BWR OWNERS' GROUP

BWROG-00073
July 20, 2000

SUBJECT: ***BWR Owners' Group Appendix R Fire Protection Committee Use of Safety Relief Valves and Low Pressure Systems as Redundant Safe Shutdown Paths, GE Report No. GE-NE-T43-00002-00-03-R01, August 1999***

BWROG Comments
On the NRC (PSA Branch)
Risk Assessment of the
BWROG Position on the Use of
Safety Relief Valves and Low Pressure Systems
As Redundant Safe Shutdown Paths

Figure 1 - SRV/LPS Protected as Required Safe Shutdown Path

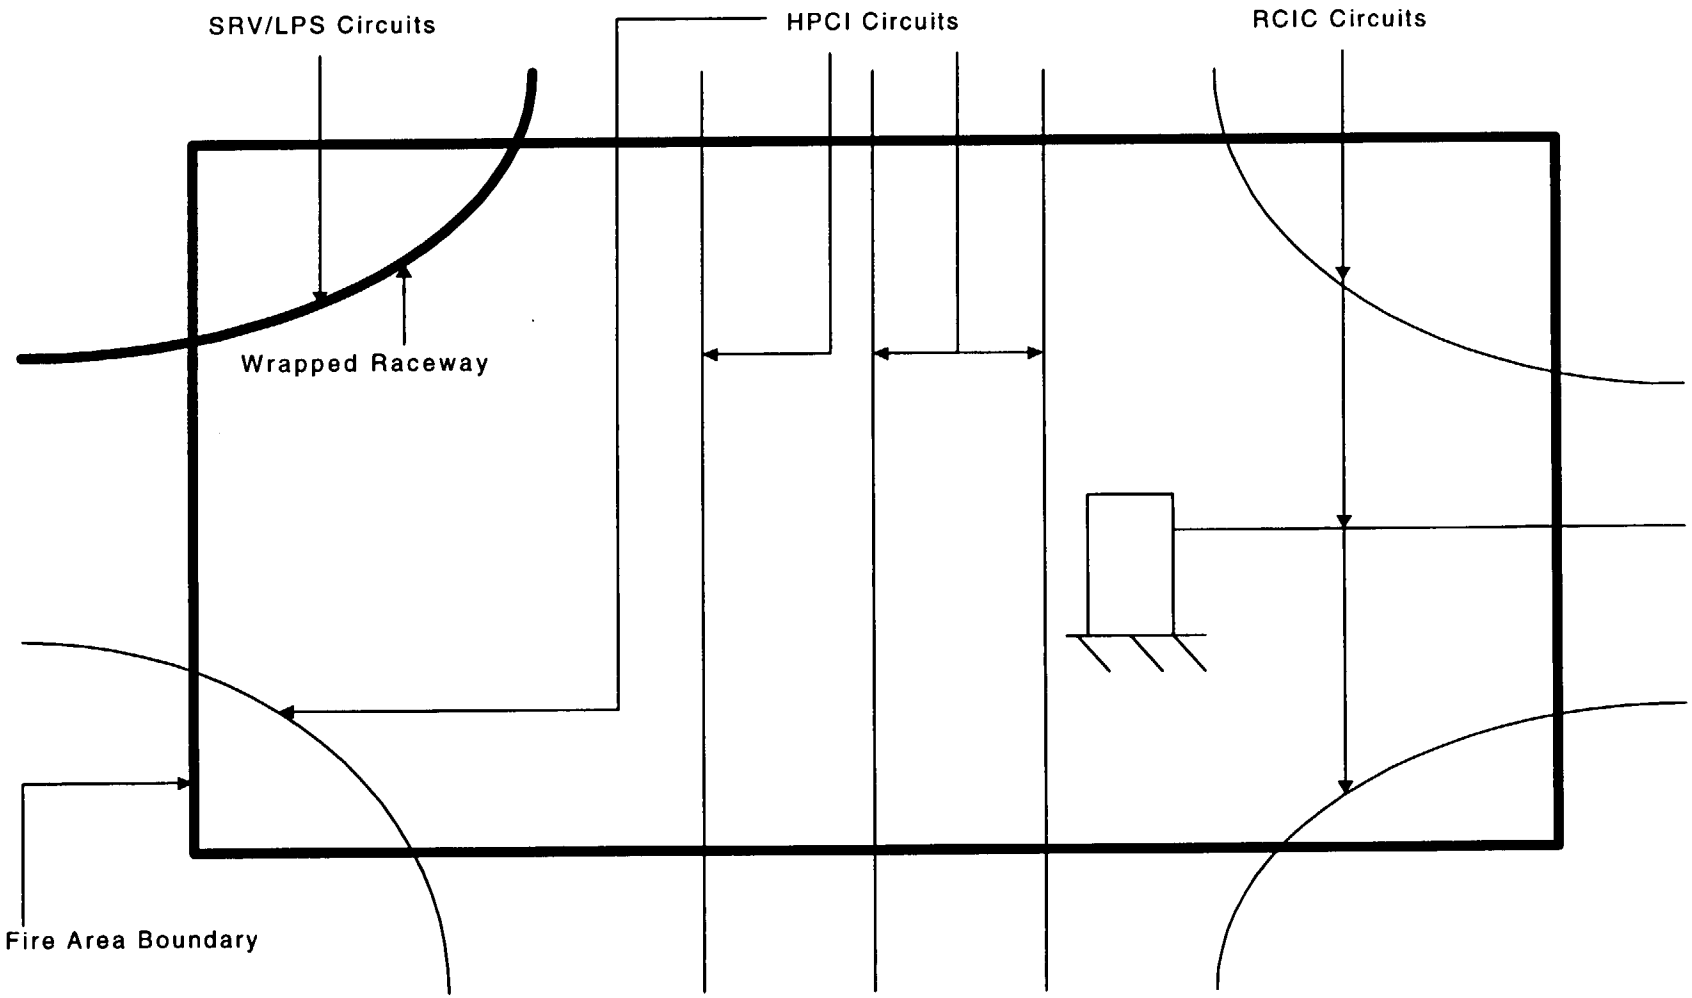
Regarding assumption No. 1 above, BWRs have extensively used SRVs/LPS as Redundant Safe Shutdown Paths in situations where the SRV/LPS path is **not** independent of the fire area under evaluation. As shown in the attached Figure 1, circuits for the SRV/LPS safe shutdown path are routed in the same fire areas as circuits for

HPCI/HPCS, RCIC and other means of achieving and maintaining safe shutdown. It is the BWROG's Position that safe shutdown paths using SRVs/LPS are acceptable Redundant Safe Shutdown Paths. The BWROG considers safe shutdown paths using SRVs/LPS to be redundant and equivalent to safe shutdown paths using HPCI/HPCS, RCIC or any other means of achieving and maintaining safe shutdown. As shown in the attached Figures 1 and 2, BWRs have protected the redundant safe shutdown path that is least affected by the fire. If SRV/LPS was the least affected path, it would be selected as the required safe shutdown path (Refer to Figure 1). Conversely, if HPCI were the least affected path, it would be selected as the required safe shutdown path (Refer to Figure 2). The BWROG also believes that the licensing basis citations provided in Attachment 2 to this letter substantiate the fact that the use of SRVs/LPS has been approved by the NRC staff as a Redundant Safe Shutdown path. Therefore, the assumption that SRVs/LPS are used as Alternative Shutdown Paths and are independent of the fire area under evaluation is not applicable to the BWROGs position on the use of SRVs/LPS as Redundant Safe Shutdown Paths.

Figure 1 - SRV/LPS Protected as Required Safe Shutdown Path

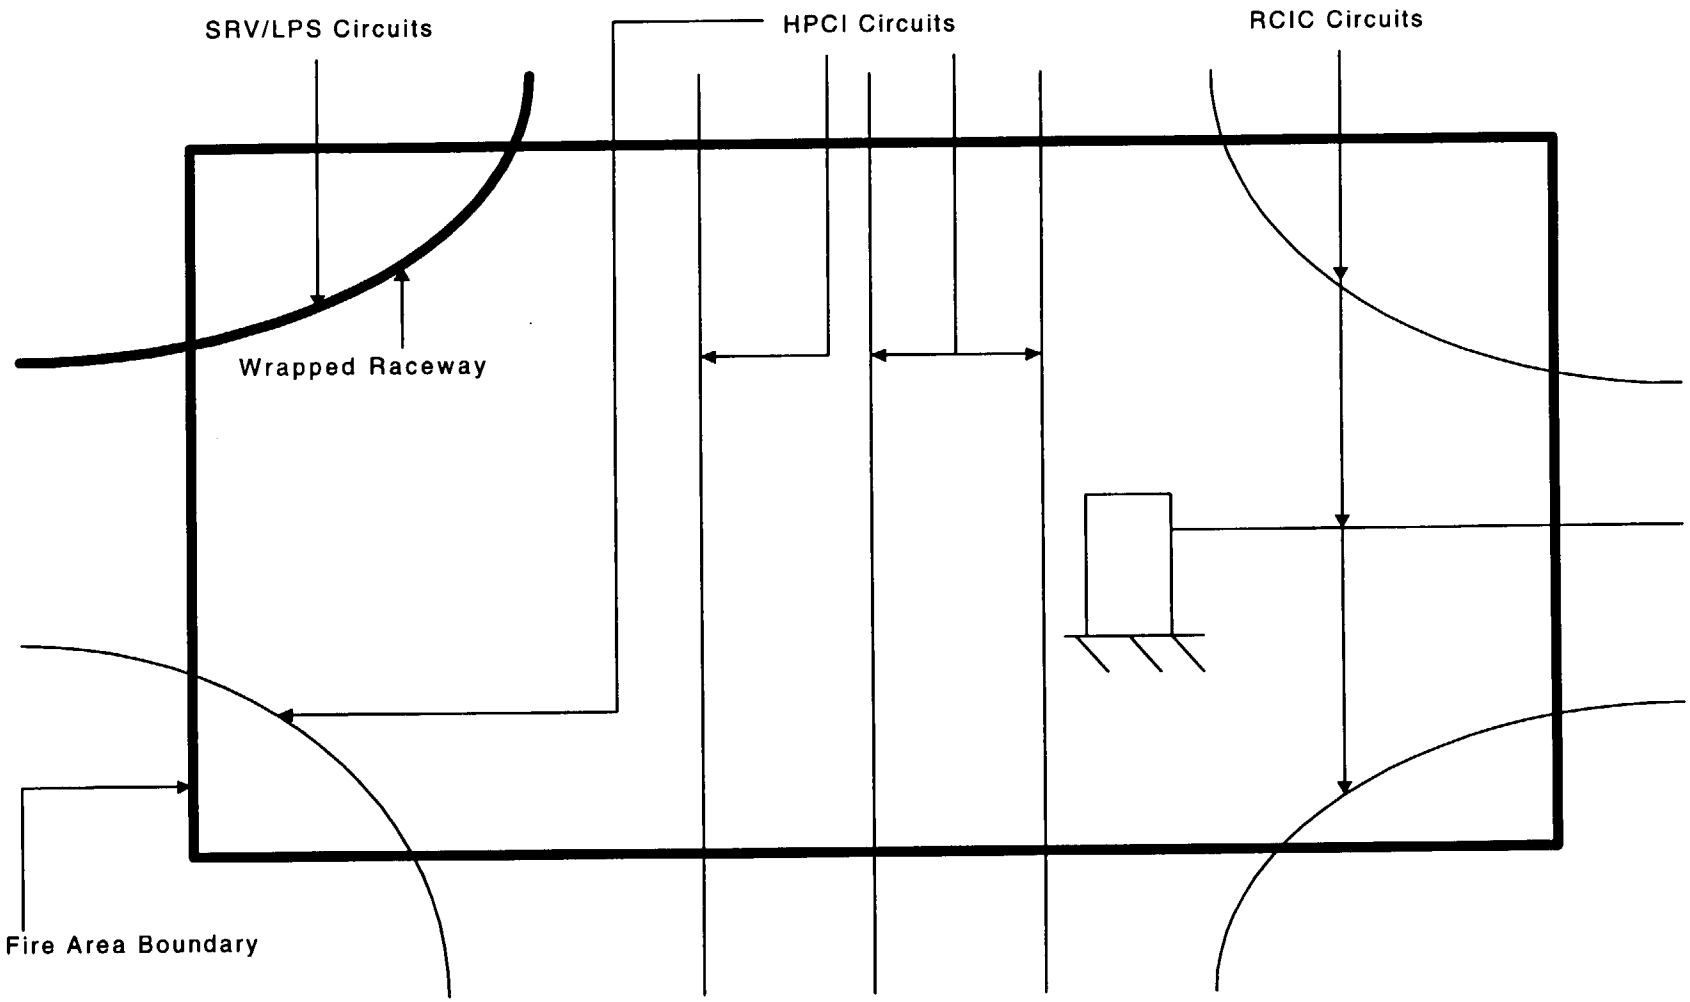
Regarding assumption No. 1 above, BWRs have extensively used SRVs/LPS as Redundant Safe Shutdown Paths in situations where the SRV/LPS path is **not** independent of the fire area under evaluation. As shown in the attached Figure 1, circuits for the SRV/LPS safe shutdown path are routed in the same fire areas as circuits for
